Flight Procedures Cover Page	Task Action: FLIGHT CHECK	Task Type: SID	Estimated Chart Date: 09/03/2026	APWS Task ID: CDFC729872FB4C6F8F3556916D8AE575	APWS Project ID: 7E36E542A7DD45EA9280F90A152F748D
Procedure: HRPER FOUR DEPARTURE (RNAV)		Enroute: YES	Specialist: Palmer, Leo	Agreement Number:	
Airport ID: KDFW			Airport City: DALLAS-FORT WORTH	State: TX	
Facility ID:	Facility Type:	Flight Inspection Remark Type: New FC Slot

PROCEDURE: HRPER FOUR DEPARTURE (RNAV)		AIRPORT NAME: DALLAS-FORT WORTH INTL		AIRPORT ID: KDFW	SPECIAL CONTROL NO: OG-03-148-26
FAC ID: HRPER4		CITY: DALLAS-FORT WORTH		ST: TX	ORIG CHART DATE: 09/03/2026
DFL TYPE: PROC/D	THIRD PARTY: <input type="checkbox"/> YES	EST. TIME ON SITE: 1.0	REIMB. NUMBER:	PTS TASK ID: CDFC729872FB4C6F8F3556916D8AE575

HRPER THREE DEPARTURE (RNAV)
(HRPER3, HRPER) 04FEB16

PROTOTYPE-NOT FOR NAVIGATION

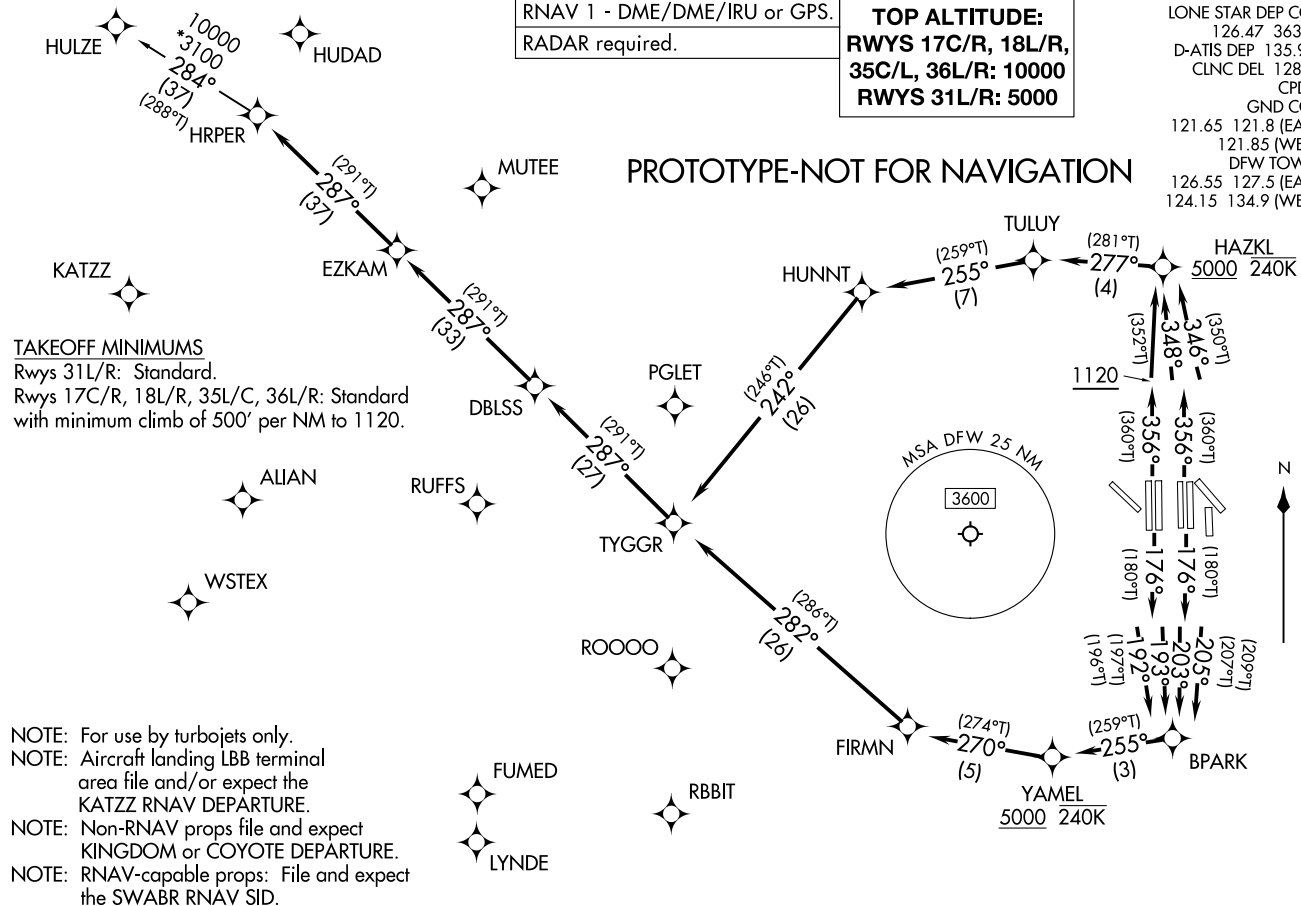
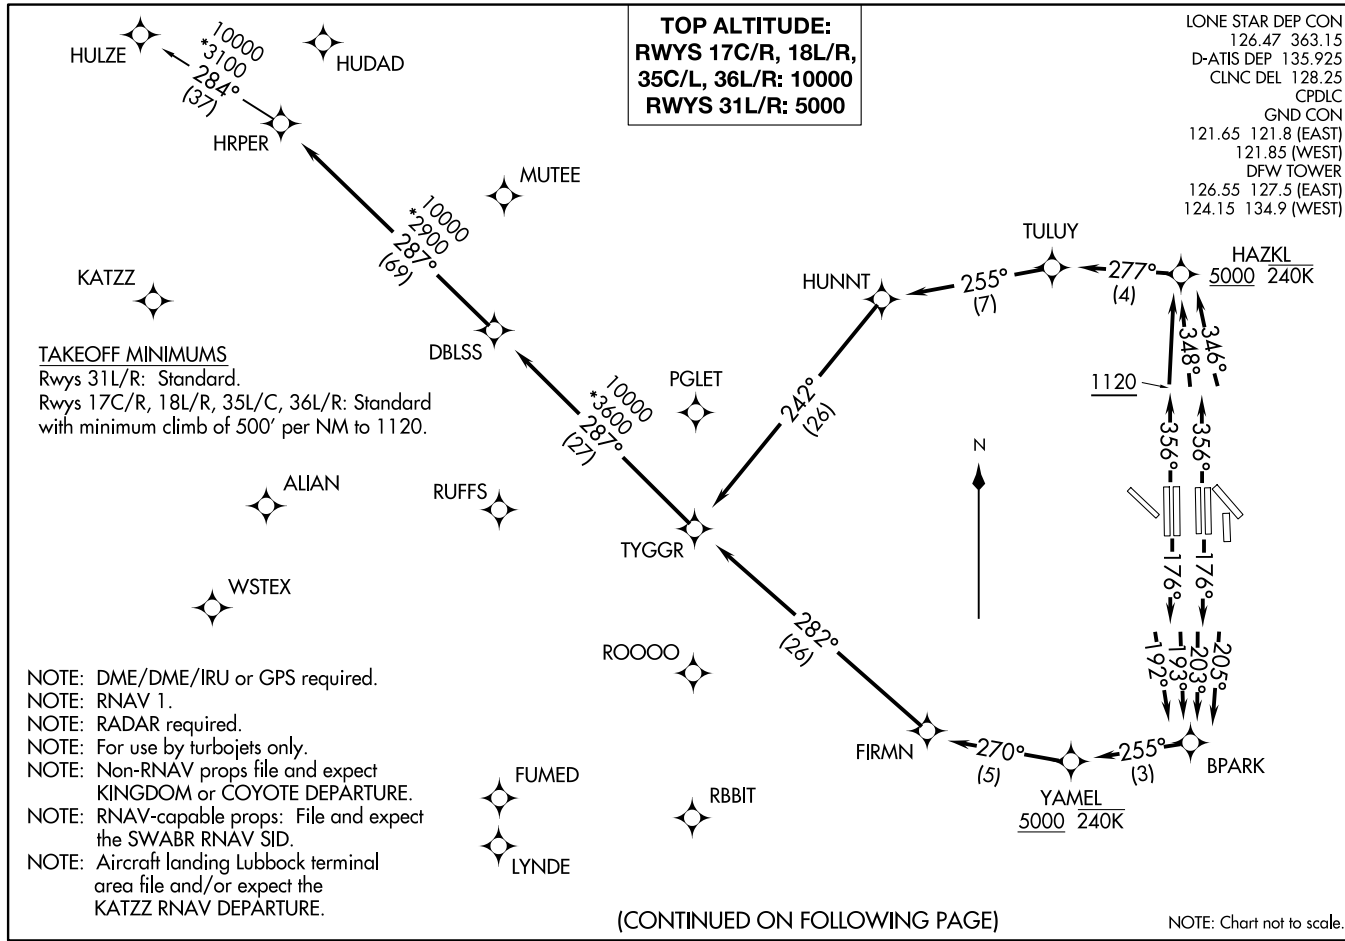
1. DP ROUTE DESCRIPTION: RWY 17C, 17R, 18L, 18R, 35C, 35L, 36L, 36R, REMOVED RUNWAY TRANSITION DESCRIPTION AFTER FIRST TF LEGS, YAMEL AND HAZKL - PER AFS.
2. COMMON ROUTE: RWY 17C, 17R, 18L, 18R, 35C, 35L, 36L, 36R, REMOVED COMMON ROUTE DESCRIPTION AND REPLACED WITH "THEN ON DEPICTED ROUTE TO HRPER" - PER AFS.
3. COMMON ROUTE: RWY 31L/R, REMOVED COMMON ROUTE DESCRIPTION AND REPLACED WITH "THEN ON DEPICTED ROUTE TO HRPER" - PER AFS.
4. PROCEDURAL DATA NOTES: REMOVED "NOTE: RNAV-CAPABLE PROPS: FILE AND EXPECT THE SWABR RNAV SID.", "NOTE: NON-RNAV-CAPABLE PROPS: FILE AND EXPECT KINGDOM OR COYOTE DEPARTURE."- PROCEDURE DESIGNATED FOR USE BY TURBOJETS. - PER AFS.
5. FIXES AND/OR NAVAID: REMOVED IAW 8260.46 DOCUMENTATION STANDRAD - NOT ALLOWED ON RADAR VECTOR SID. - PER AFS.
6. REMARKS: REMOVED RECCOMENDED NAVAID PGO. - NO LONGER REQUIRED ON RNAV SID. - IAW 8264.46 DOCUMENTATION STANDARDS.

1. DEPARTURE ROUTE DESCRIPTION: RWY 31 L/R ROUTE DESCRIPTION, AND ROUTE CONTINUATION COMBINED WITH ALL RUNWAYS. - PER AFS
2. REMARKS: ADDED "WAIVER ON FILE FOR RWY 31 L/R VECTORS BELOW THE MVA." - ADDITIONAL WAIVER REQUIERED PER AFS.

1. RWY 31 L/R DEPARTURE ROUTE DESCRIPTION AND CODING CHANGED FROM "CLIMB HEADING ASSIGNED BY ATC, FOR VECTORS TO TYGGR, THENCE..." TO "TAKEOFF RWY 31L: CLIMB ON HEADING 315.06 TO 1109, FOR VECTORS TO TYGGR, THENCE...." AND "TAKEOFF RWY 31R: CLIMB ON HEADING 311.28 TO 1109, FOR VECTORS TO TYGGR, THENCE...." 8260.15C CODING CHANGED FROM VM/DF TO VA/VM. - PER AFS - IAW 8260.46K 3-1-6 B (3).
2. REMARKS: ADDED WAIVER ON FILE FOR ATC REQUESTED MAINTAINED ALTITUDE LOWER THAN THE UNRESTRICTED CLIMB ALLOWED BY TERPS EVALUATION", - ADDITIONAL WAIVER REQUIRED PER AFS.
3. REMARKS: REMOVED "WAIVER ON FILE FOR TERMINOLOGY USED IN DP ROUTE DESCRIPTION FOR RWY 31L/R (CLIMB HEADING ASSIGNED BY ATC)." - PER AFS NO LONGER REQUIRED, SUPPORTED BY CRITERIA.

TAKEOFF RUNWAY 17C: Climb on heading 176° to intercept course 205° to BPARK, then on track 255° to cross YAMEL at or above 5000 and at or below 240K, thence

TAKEOFF RUNWAY 17R: Climb on heading 176° to intercept course 203° to BPARK, then on track 255° to cross YAMEL at or above 5000 and at or below 240K, thence

TAKEOFF RUNWAY 18L: Climb on heading 176° to intercept course 193° to BPARK, then on track 255° to cross YAMEL at or above 5000 and at or below 240K, thence

TAKEOFF RUNWAY 18R: Climb on heading 176° to intercept course 192° to BPARK, then on track 255° to cross YAMEL at or above 5000 and at or below 240K, thence

TAKEOFF RUNWAY 35C: Climb on heading 356° to intercept course 346° to cross HAZKL at or above 5000 and at or below 240K, then on track 277° to TULUY, thence

TAKEOFF RUNWAY 35L: Climb on heading 356° to intercept course 348° to cross HAZKL at or above 5000 and at or below 240K, then on track 277° to TULUY, thence

TAKEOFF RUNWAYS 36L/R: Climb on heading 356° to 1120, then direct HAZKL to cross at or above 5000 at or below 240K, then on track 277° to TULUY, thence

TAKEOFF RUNWAYS 31L/R: Climb on assigned heading for vectors to TYGGR, thence...

. . . . on depicted route to HRPER, then on transition. Maintain (Rwy 31L/31R) 5000 /
